Latest silicon ladder

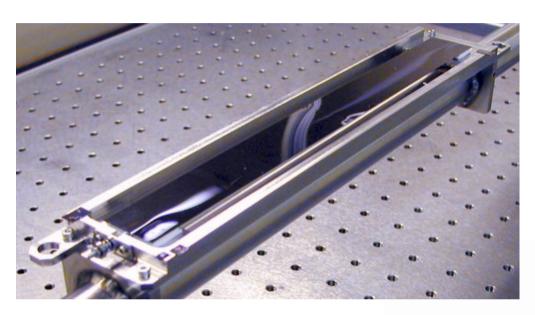
- Silicon ladder suffers distortions
 - This is due to the different co-efficients of expansion

Cross section through ladder end block

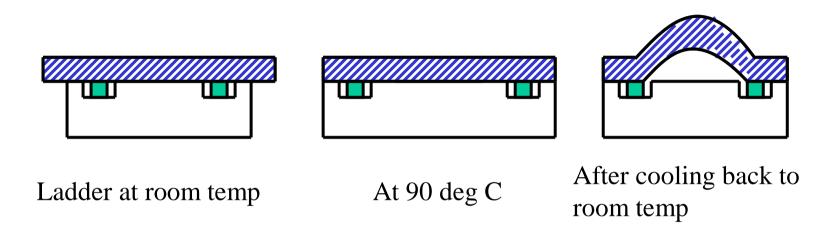
Problem needs to be solve as will return when trying bump bonding

Suggest making one channel to put glue down
